GEOTECHNICAL REVIEW, DRAINAGE ASPECTS

MAIN EMBANKMENT DAM

TAILINGS STORAGE FACILITY

MT. POLLEY PROJECT, BRITISH COLUMBIA

Photo 9. East Side of Main Embankment Seepage Collection Pond. Looking North.

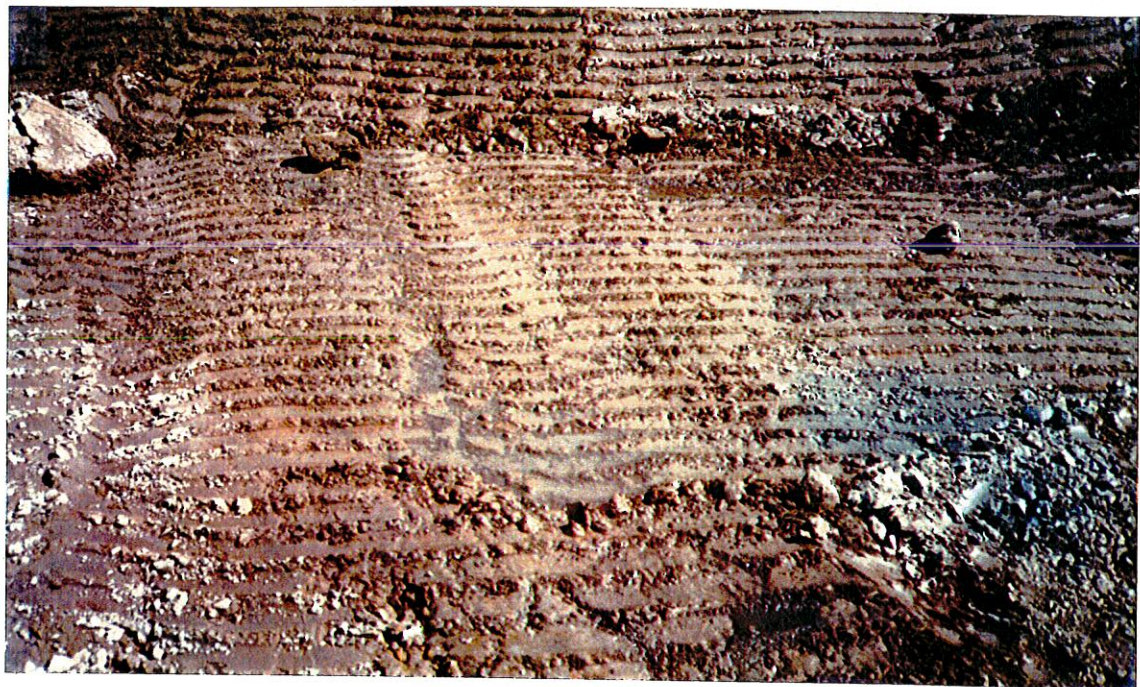
probably the glaciofluvial/glaciolacustrine formation, from which slight seepage appeared to be taking place (see Photo 10). The majority of the water in the Pond (Photos 8, 9 and 12), however, appears to originate from discharge from the Drain Monitoring Sump outlet, as shown in Photo 11. The top of the Monitoring Sump is shown in Photo 13, and inspection of the interior showed flow from each of the drain pipes entering the Sump.

Photo 19. Exposure in base of Reclaim Barge Channel, East Side, Near South end.

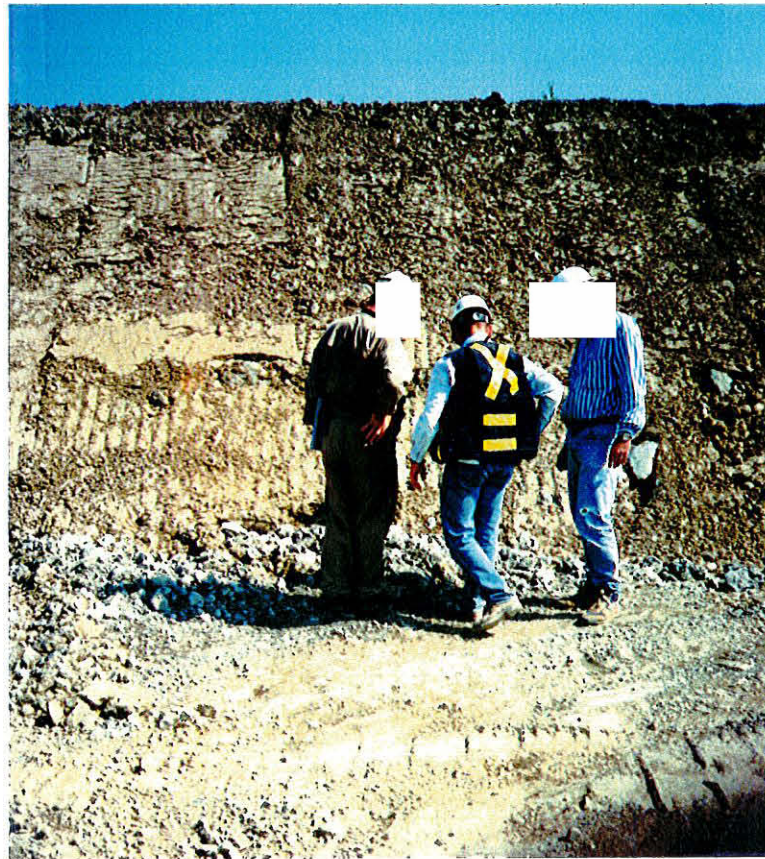
The till cap appears to have been completely removed locally in the base of the Reclaim Barge Channel (Ref. 9.8 and Photo 19, Appendix I). It was also recommended that these local areas be checked and sealed, as required. Similarly the local area, (probably a former stream bed) at the upstream edge of the Basin Liner. (Photo 17 in Appendix I).
